**Port Stephens
Local Traffic Committee Minutes**

**Meeting held in the Port Stephens Council Committee room and via Zoom on
Tuesday 3rd October 2023, at 9:30am**

Medowie Road, Williamstown – Safety concerns

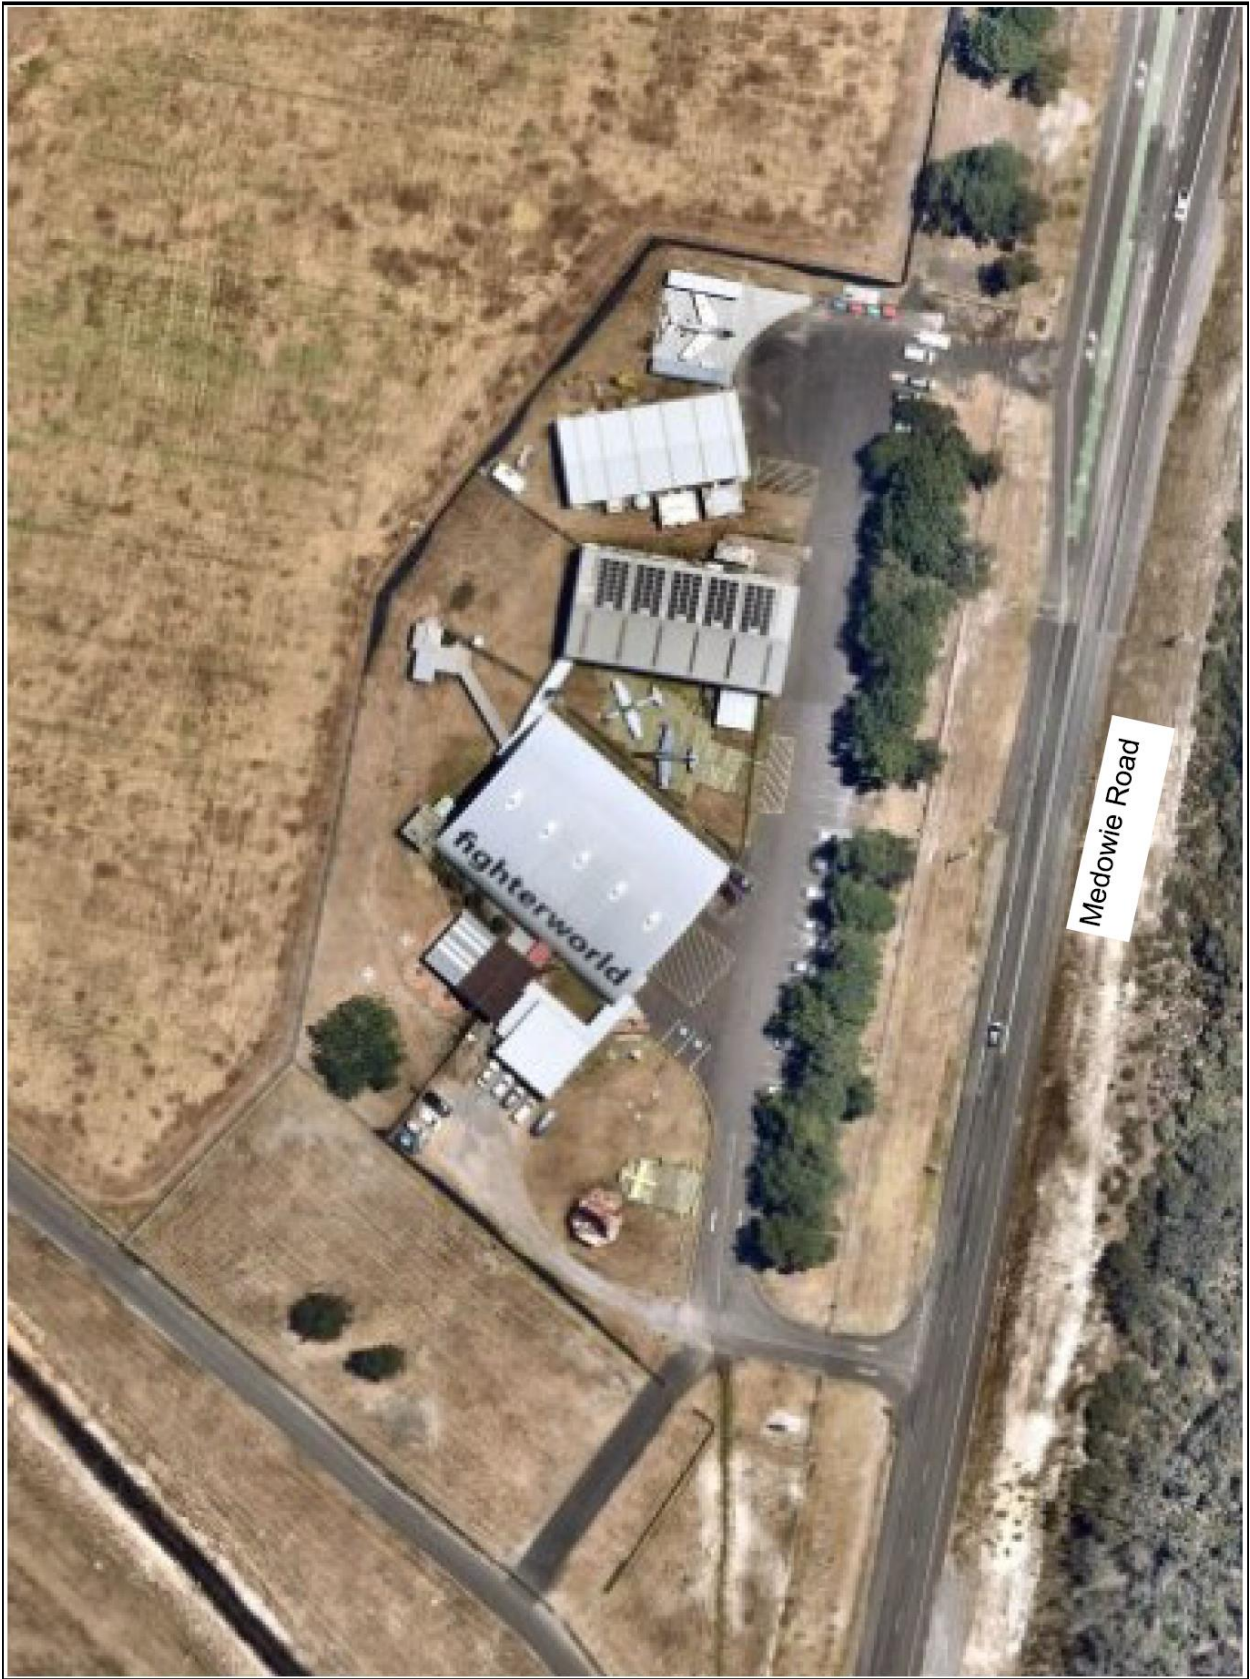
- CHR (short) – Would require significant shoulder works over the length of the site with regard to the ADT / speed / HV % (B Double route)
- No Right turn – Left-in Left-out – would likely result in U-turns north and south of existing entrance
- Potential internal road connection to the south entrance of RAAF Base, including closure of the Fighter World Medowie Road access
- Activate a northern entrance to Fighter World with redesign of lanes and linemarking of RAAF Southgate turn in /out lanes on Medowie Rd

Local Traffic Committee members noted that without recorded crash data, it is difficult to establish a pattern of incidents. It was also noted that left-in / left-out restrictions, even with a median, would result in unsafe turning manoeuvres. It was recommended that warning signs be provided in the short-term and that Council officers investigate further options.

It was recommended that warning signs be provided in the short-term and that Council officers investigate further options.

Masonite Road, Heatherbrae – Roundabout design

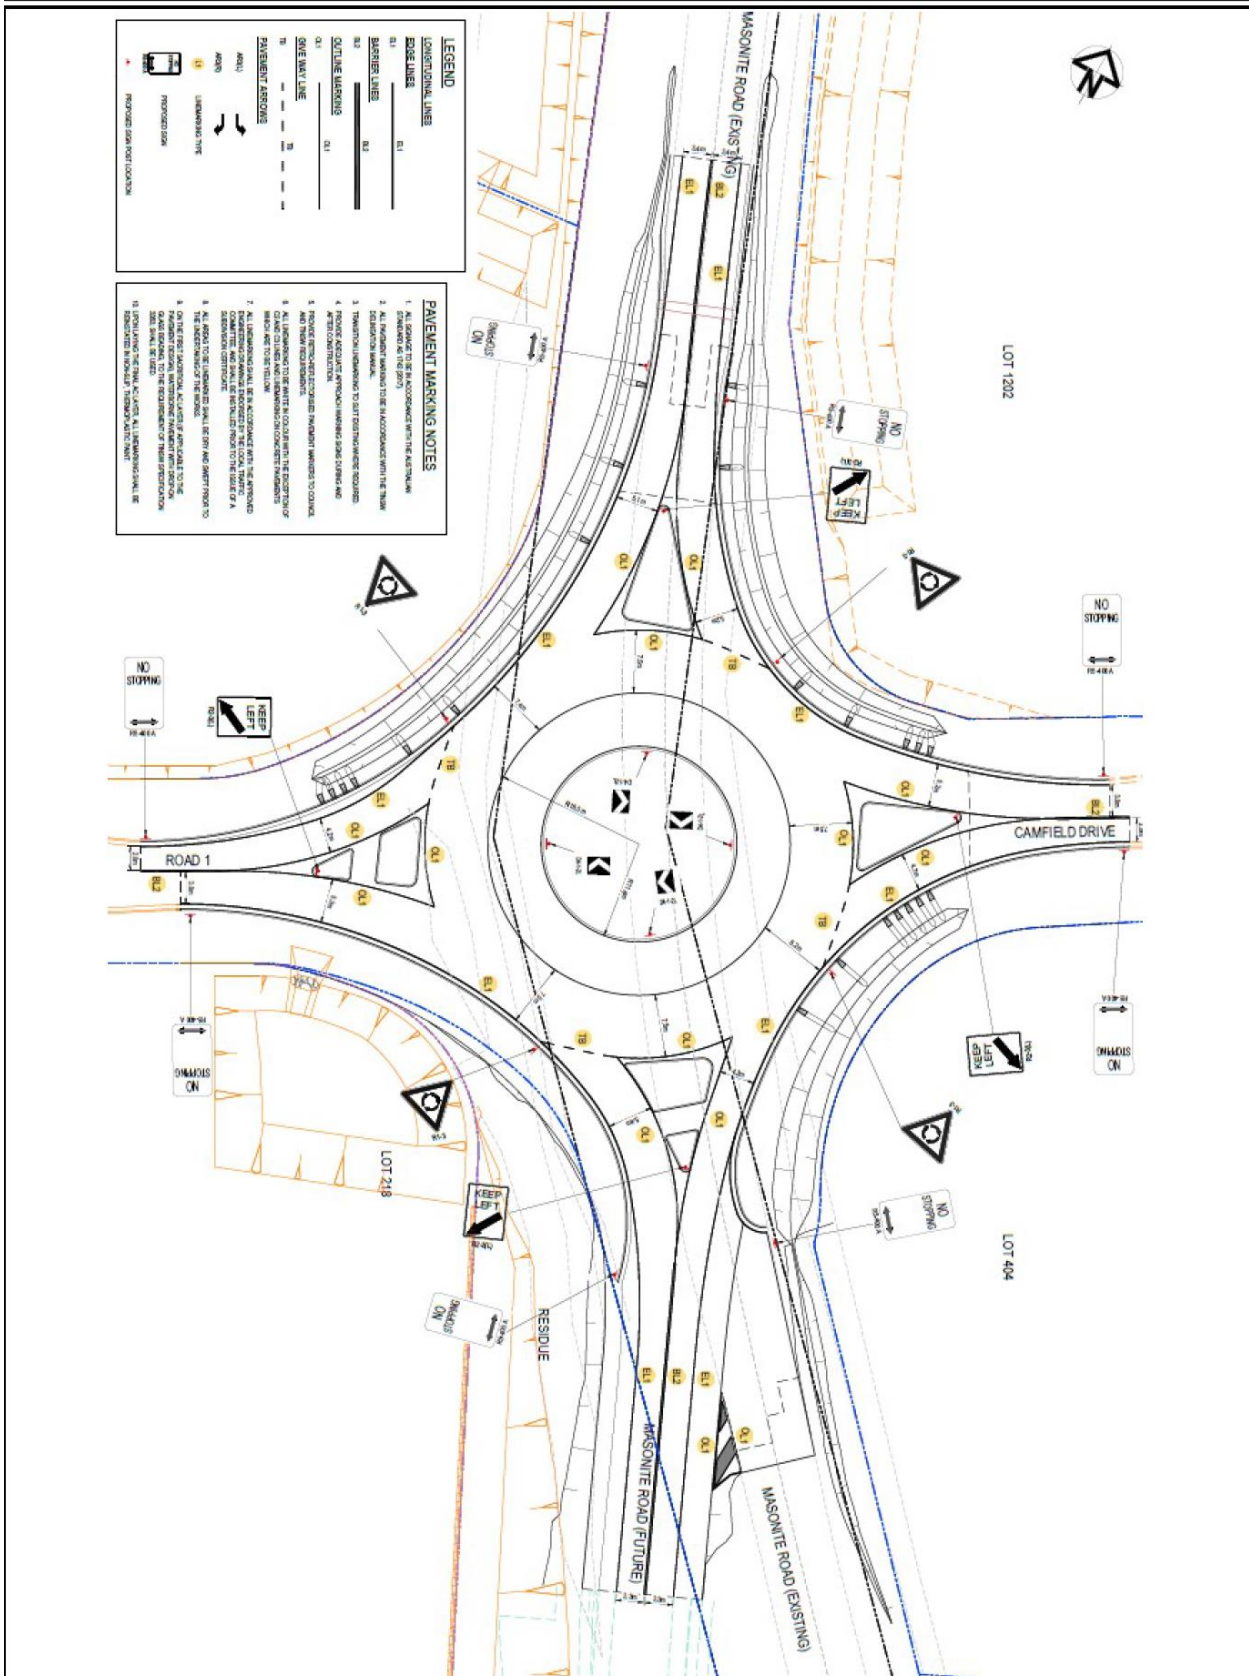
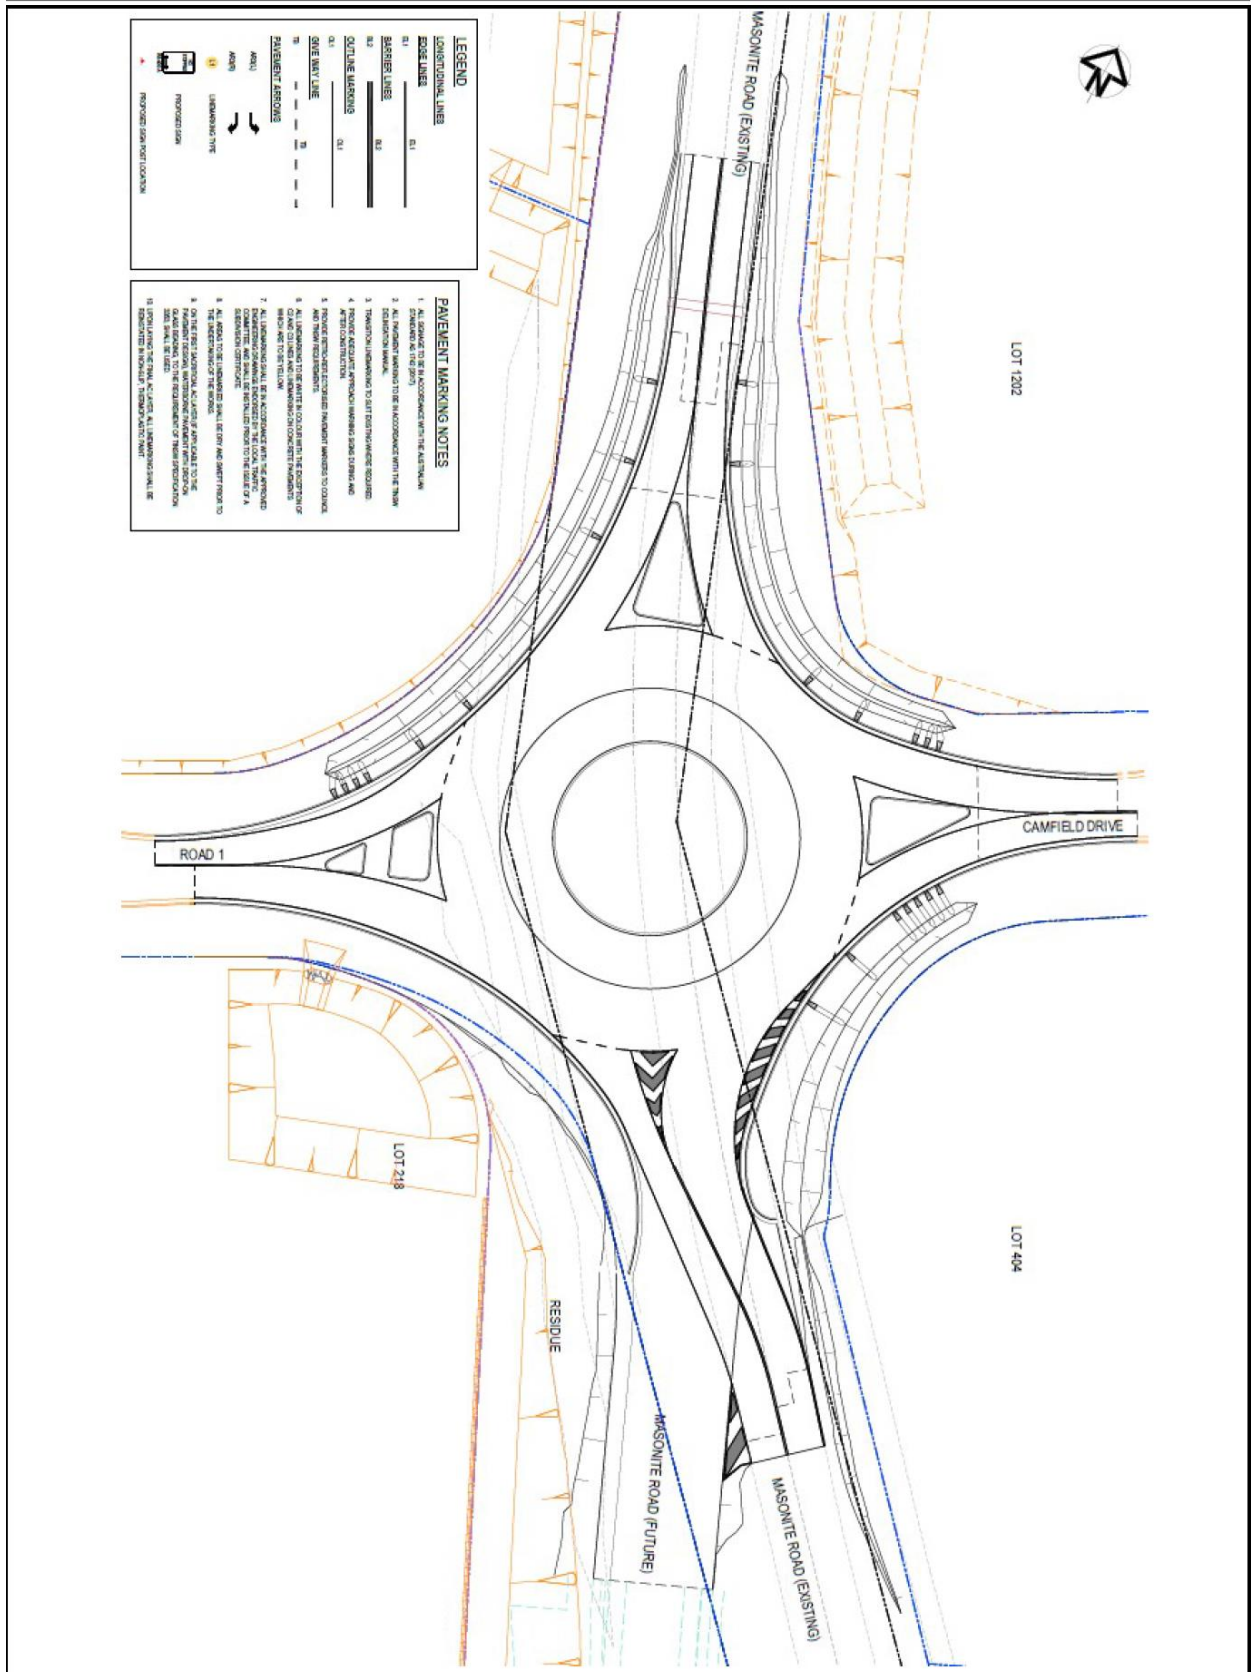
The TfNSW representative noted that splitter islands need to meet minimum design requirements and that kerb ramps and splitter islands should be provided on all legs of the roundabout

Accept the linemarking and signage plans for the new proposed Stage 2 Roundabout Connection at Kinross Estate, Heatherbrae, as shown on the attached sketches, Annexure A.

Medowie Road, Medowie - Connection to Tall Trees Estate

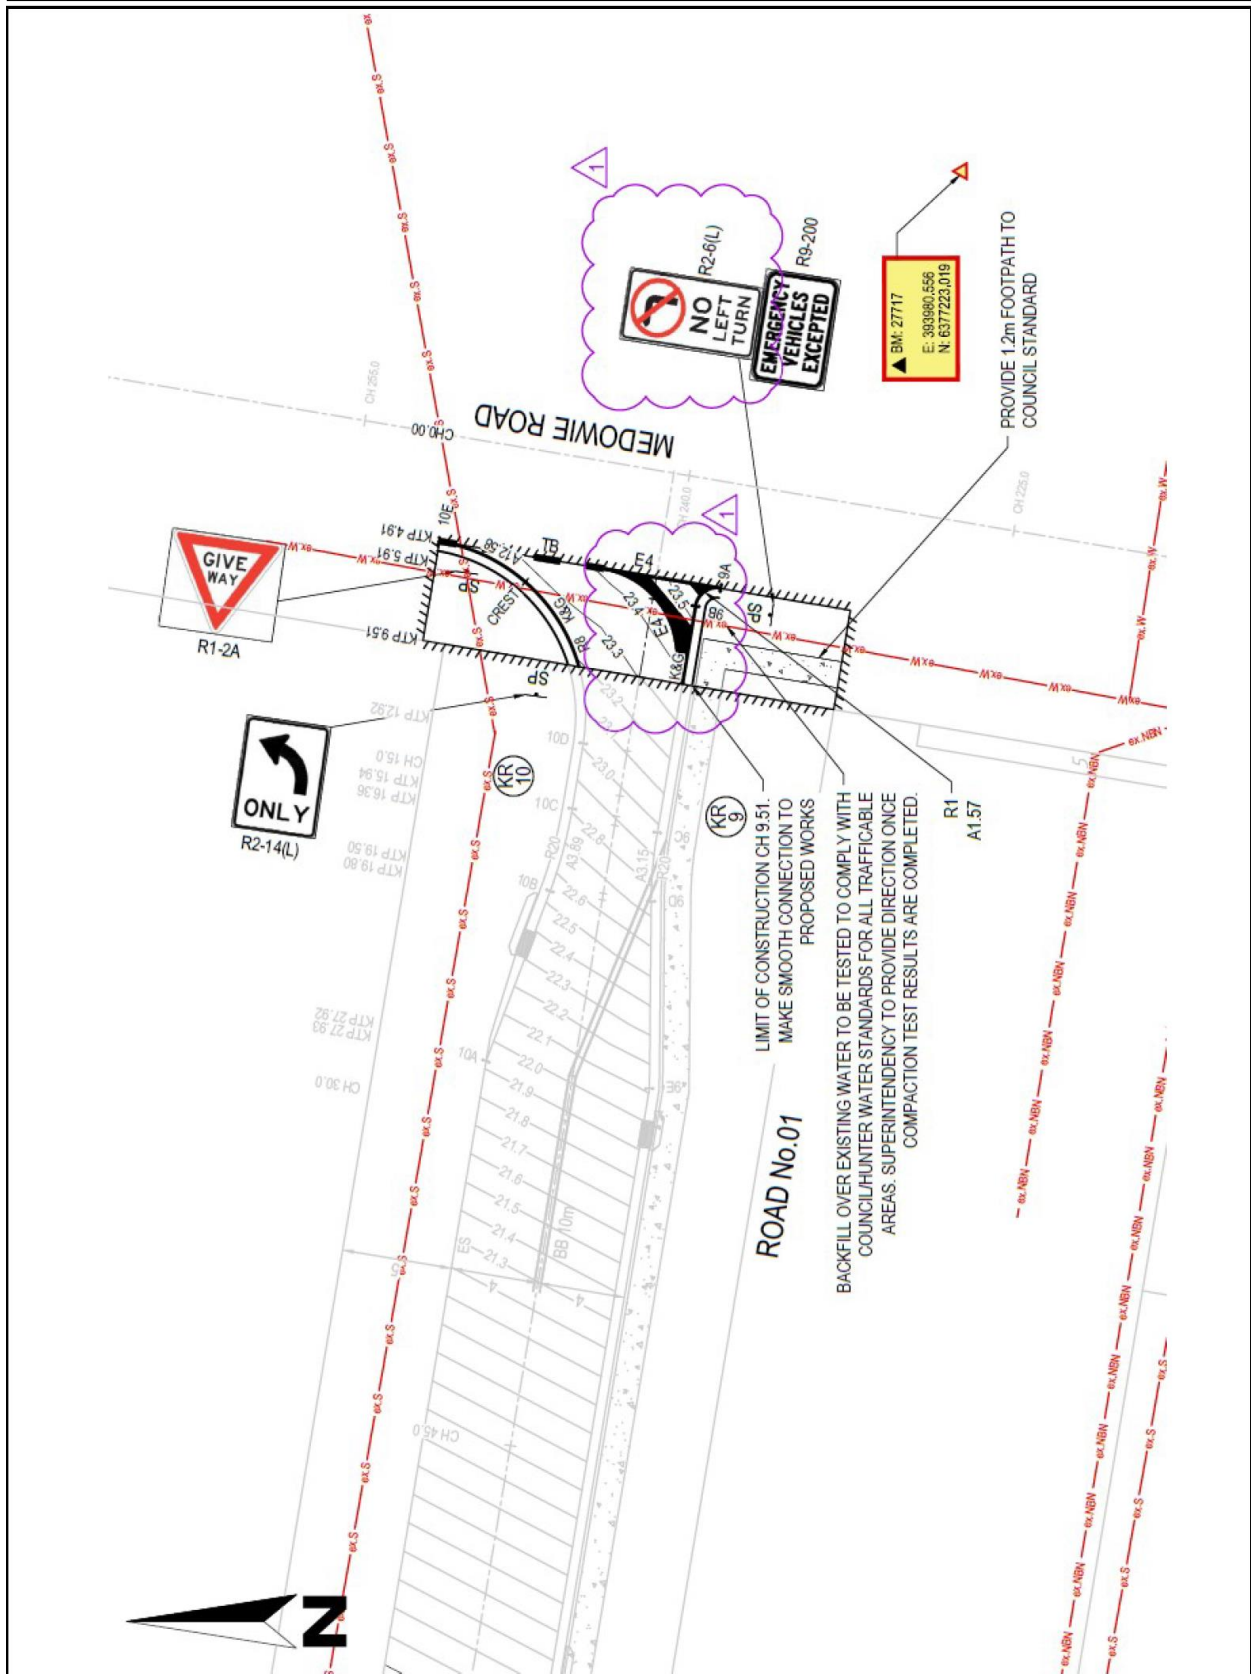
The proposed R9-200 sign – ‘Emergency Vehicles Excepted’, is not delegated for Council installation and requires direct, written authorisation from TfNSW.

Local Traffic Committee members noted that there would likely be little demand for traffic to access directly to or from Medowie Road.

Accept the proposed linemarking and signage plan, as shown on the attached sketch, Annexure A.

Medowie Road Medowie – Installation of intersection controls at the Tall Trees Estate

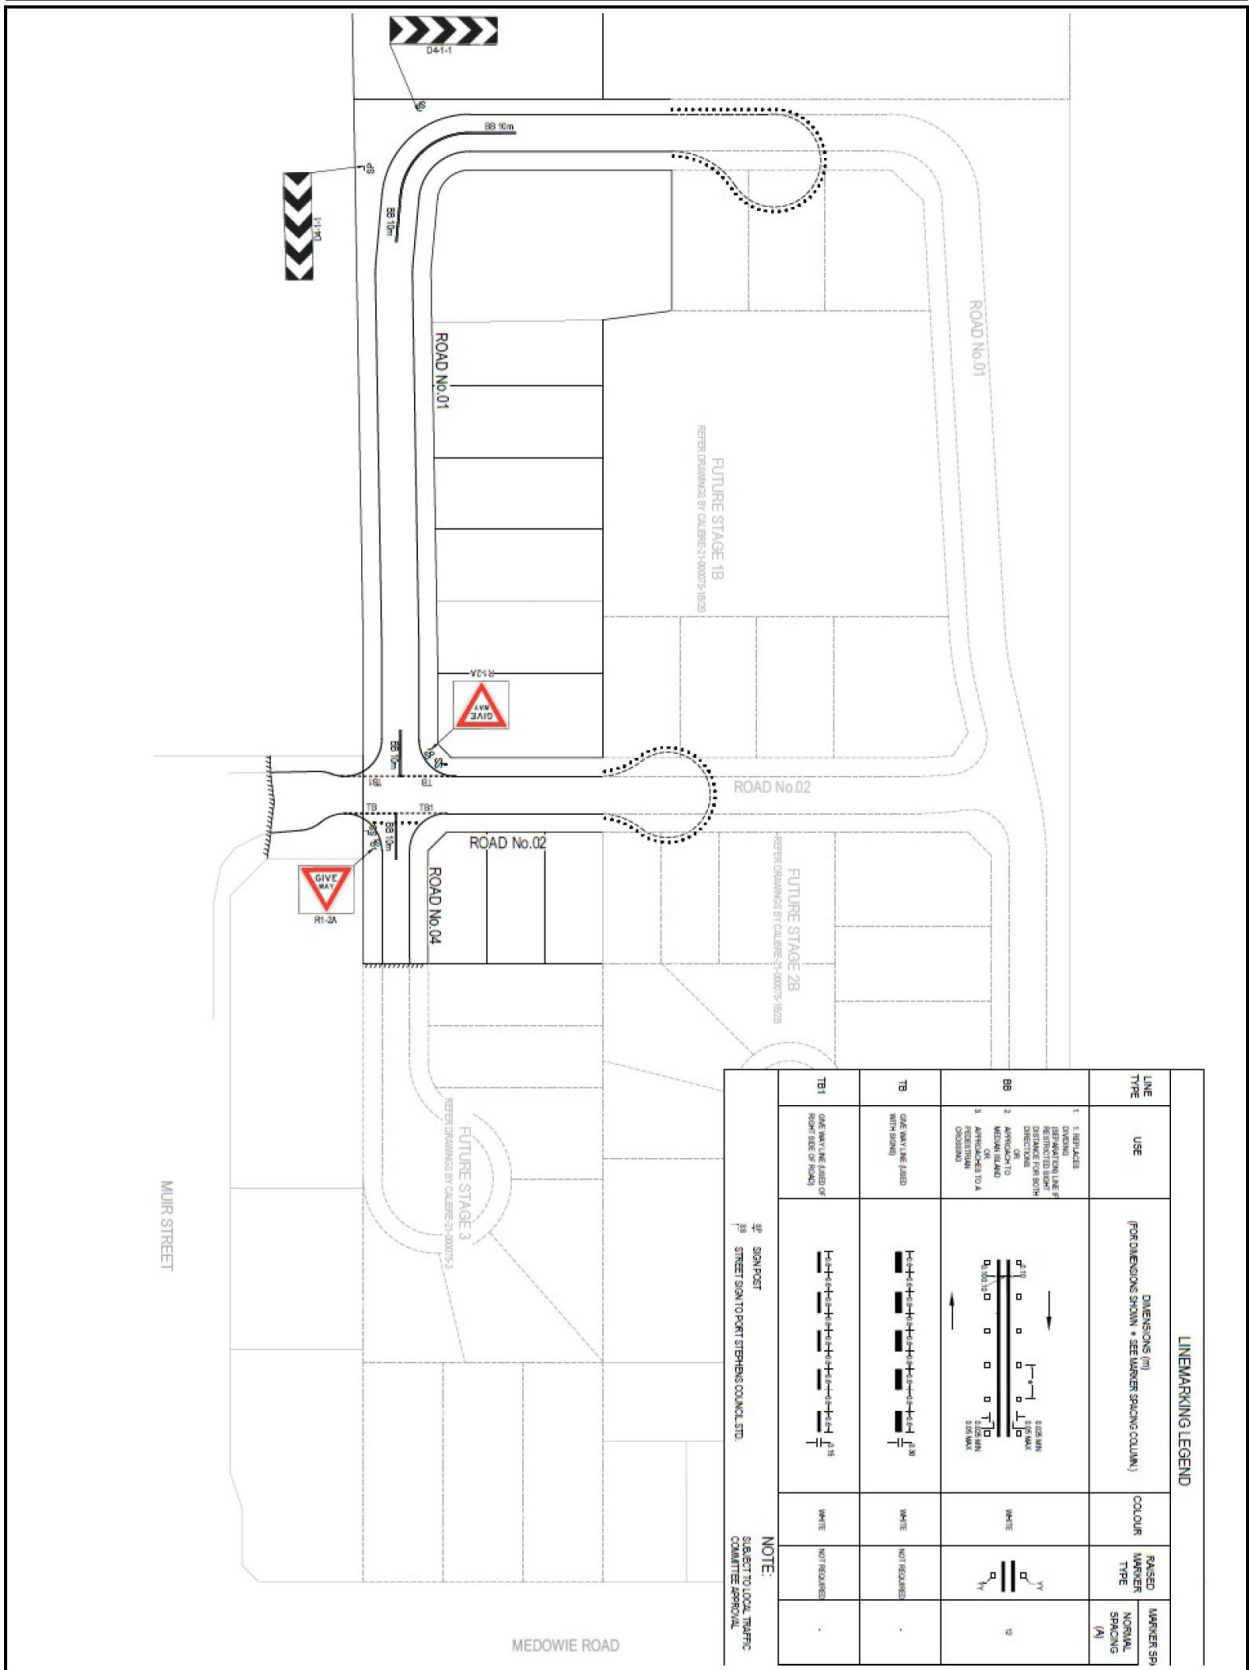
Although not in accordance with Council’s DCP, the 4-way intersection, in this instance will service low volumes of traffic, in a residential setting.

Accept the proposed signage and line marking as shown on the attached plan, Annexure A
